Date: Wednesday, July 21, 2021
To: Richard F. Gosselin, Jr, Chairman; Paul A. Piktelis, Vice Chairman; Terry Burke Dotson, Member; Mathew Ashmankas, Member; Bruce M. Devault, Member; and Millbury Planning Board
From: Steven S. Stearns (son of the owners and resident of **Map 62 Parcel 98**)
Reference: **Rice Road / South Main Street Intersection** — Public Hearing Comments
McLaughlin Family Living Trust; John Antaya; and Kathleen (McLaughlin) Mardirosian (the “owners”)
Whitney Street Home Builders, LLC (the “developer”)
17 Rice Road, Millbury, MA (a/k/a Rice Pond Village Project)

PLAN OF PROPOSED INTERSECTION IMPROVEMENTS AT RICE ROAD AND SOUTH MAIN STREET

IN
 MILLBURY, MASSACHUSETTS

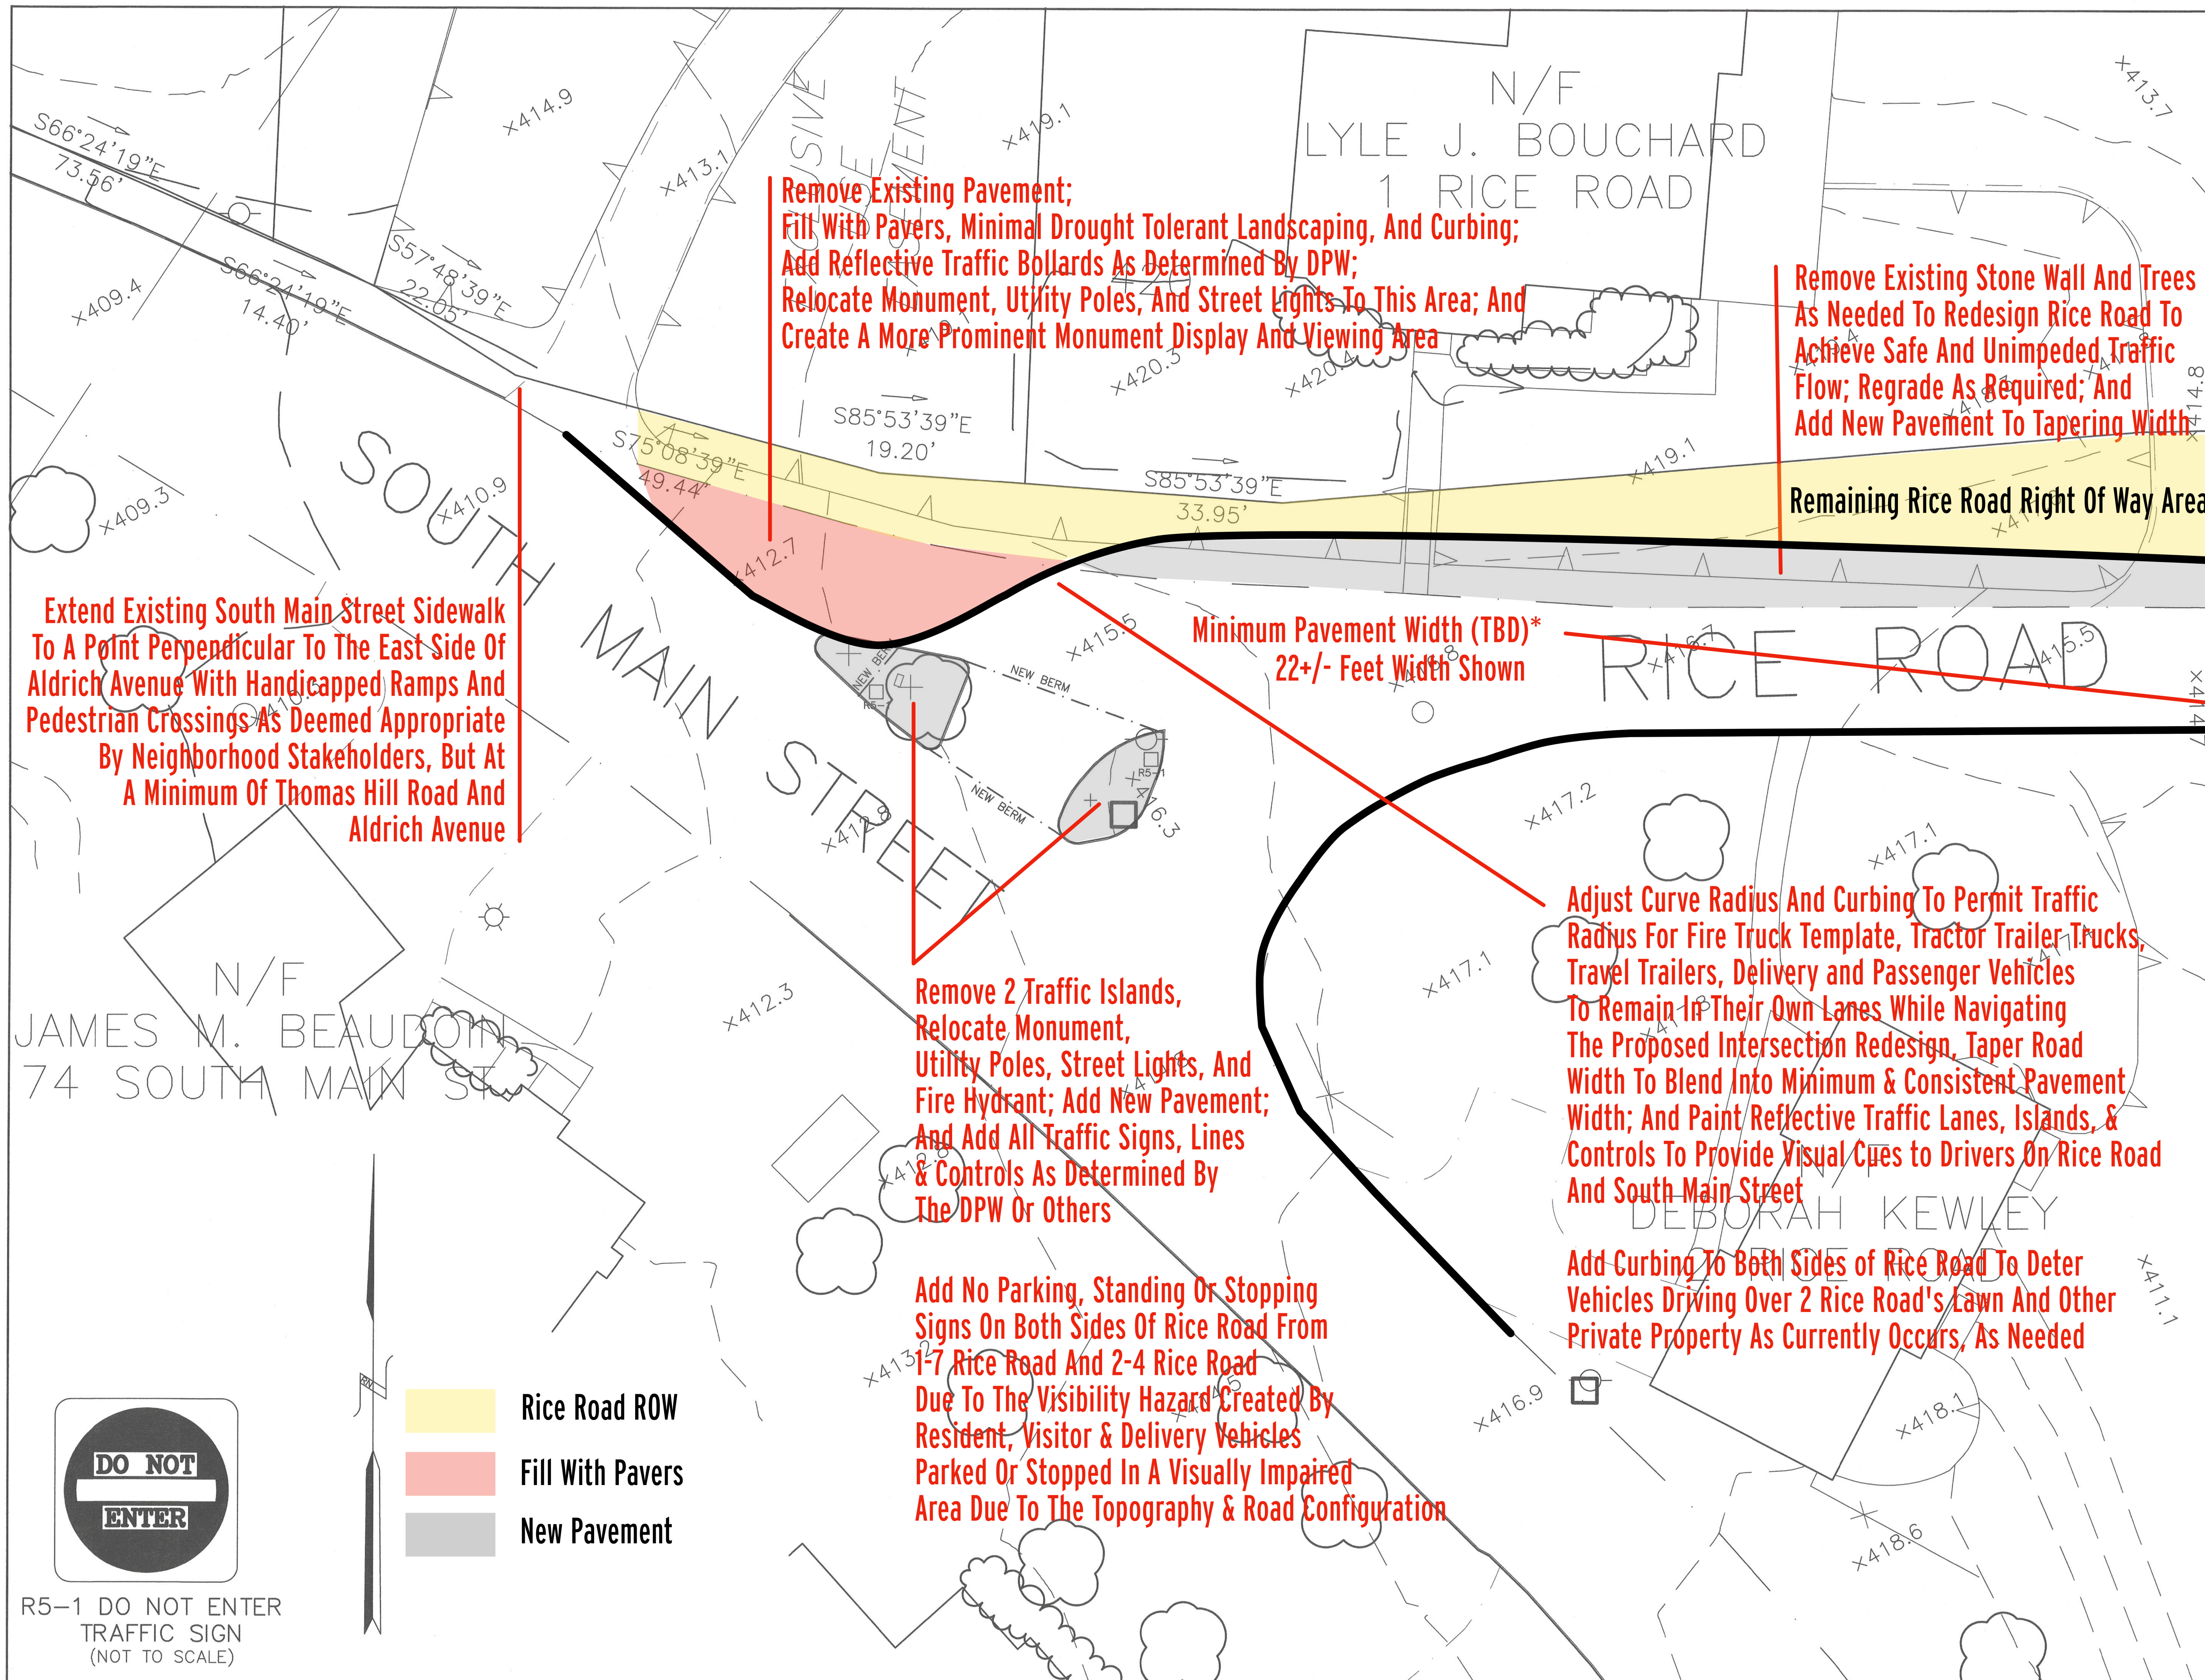
Based upon the input from members of the Planning Board, neighbors, and a conversation with the developer’s engineer, please find attached a revised version of a plan for the intersection of Rice Road and South Main Street that address the navigation and safety issues and the visibility at the Rice Road incline/decline near 1-5 Rice Road and 2-6 Rice Road, for discussion and refinement purposes.

1. The elimination of traffic islands and a portion of Rice Road that blends into South Main Street (see plan). The owner of 1 Rice Road conveyed that there was a near miss of a collision when a driver did not stop at the recently installed stop sign. Longtime residents are used to merging onto South Main Street without stopping, unless necessary.

2. Holding the existing curb line in front of 2 Rice Road as it blends from South Main Street into Rice Road.
3. Adjusting a new curb line within the Rice Road Right Of Way to permit Millbury’s Fire truck template, tractor trailer trucks, travel travelers, delivery and passenger vehicles to navigate the transitions from South Main Street to Rice Road and vice versa while remaining in their own travel lane. A reflective painted traffic island should be installed to provide visual cues to always remain within the marked travel lanes, since this is currently a hazard to the users of Rice Road. Add a stop line and sign from Rice Road to South Main Street. This new traffic pattern should encourage stopping rather than merging.

4. I have spoken to the owner of 1 Rice Road, and he is amenable to the removal of the pines trees and stone wall in the Rice Road Right Of Way to create a safer roadway design for everyone. He asked that the stone wall be reconstructed in accordance with currently Millbury regulations (i.e., on his property).

5. Curbs should be added along the frontage of 1 Rice Road and 2 Rice Road to help prevent drivers from driving over their lawns and property, as I have been told is currently occurring.

6. The area where Rice Road currently blends into South Main Street should be reclaimed as a raised paver area to prominently relocate the monument to, along with the utility pole, streetlight, and fire hydrant. Reflective traffic bollards, as determined by the DPW or Police, should be added to this new island, since this is a traffic pattern change, to protect the monument from damage and students from harm, if the School Department does not move the school bus stop.

7. The existing South Main Street sidewalk that ends at the power line side driveway of 1 Rice Road should be continued along the odd numbered side of Rice Road to a point perpendicular to the east side of Aldrich Avenue to permit safe pedestrian travel along Rice Road, which is a cut-through road that driver’s travel at a greater speed than they should. This sidewalk should be constructed to the standards as set forth in the Town of Millbury’s requirements.

8. Rice Road should be constructed to the current standards for width and any existing pavement beyond that width should be removed.
9. No parking, stopping, or standing signs should be added to both sides of Rice Road from 1 Rice Road (west property line) to 5 Rice Road (east property line) and 2 Rice Road (South Main Street) to 4 Rice Road (west property line), as vehicles parked, stopped, or standing in this area currently creates a visibility and safety hazard to the slope of Rice Road for users of the road.
